ADDENDUM #1

Project: PR004792 – CU Duane
Physics Labs Remodel

From: Pahl Architecture

Issue Date: 7/27/10

DRAWING TITLE: LEVEL 2B MECHANICAL ROOM REVISIONS TO SHEET P201

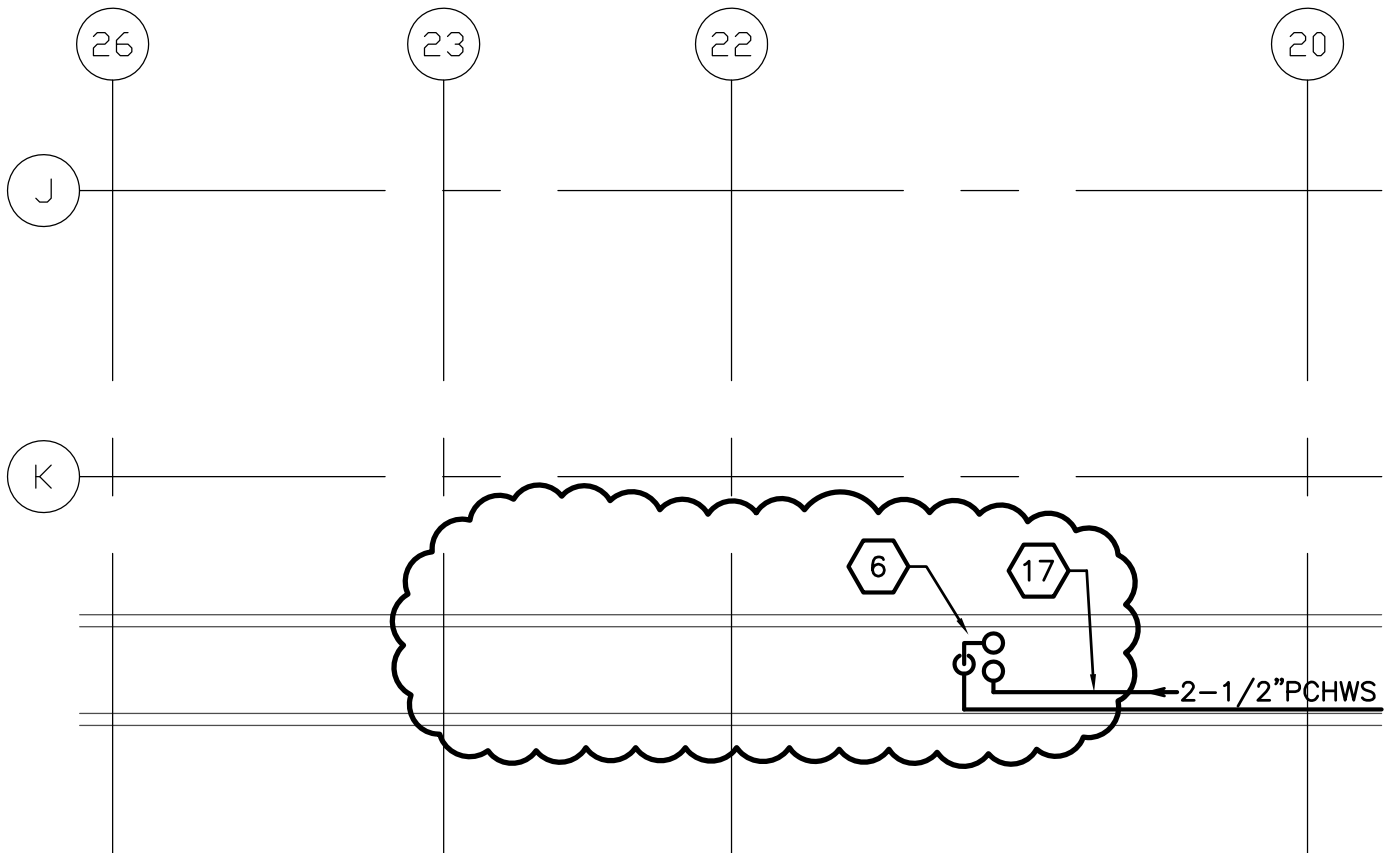
- 6** ROUTE PIPE FROM FLOOR UP TIGHT TO EXISTING PIPING AND AROUND CABLE TRAY. 2-1/2" PCHWS/R UP THROUGH FLOOR. RE: 2/P201.
- 17** PROVIDE UNISTRUT SUPPORT FOR TUNNEL PIPING.

CLIENT NAME: UNIVERSITY OF COLORADO AT BOULDER
 PROJECT NAME: DUANE RMS C-119 - C-127 LAB FITUP PR004792
 DRAWING TITLE: LEVEL 2B MECHANICAL ROOM REVISIONS TO SHEET P201

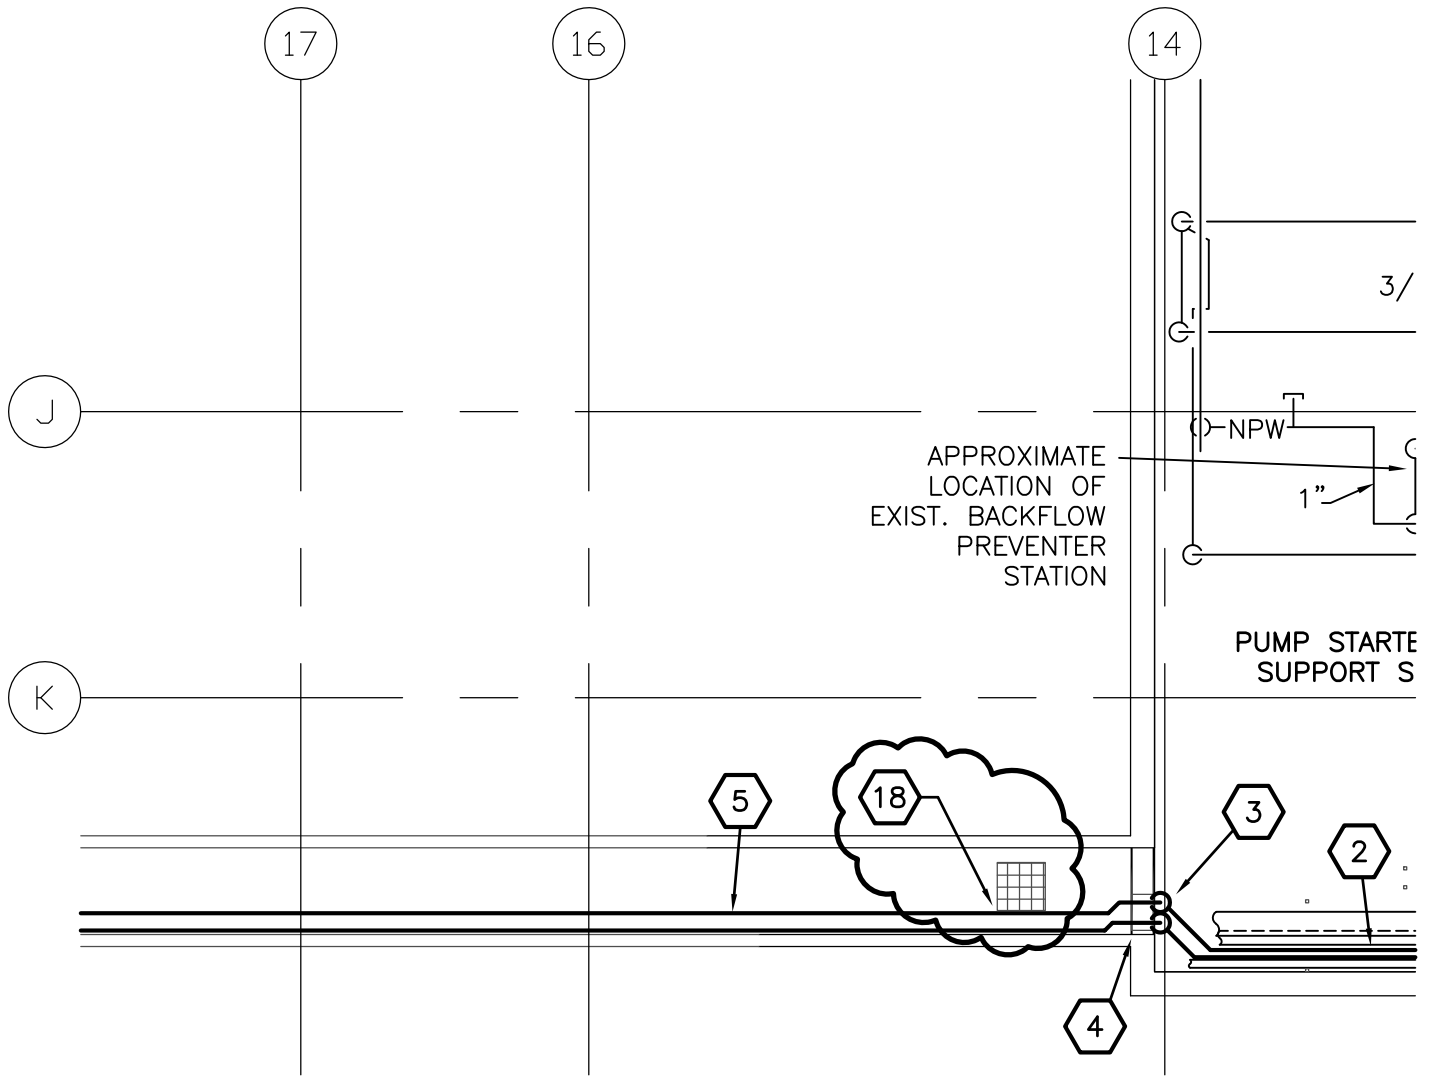
18 ROUTE PIPE TIGHT TO WALL TO AVOID ROUTING ABOVE FLOOR GRATE 12" FROM WALL.
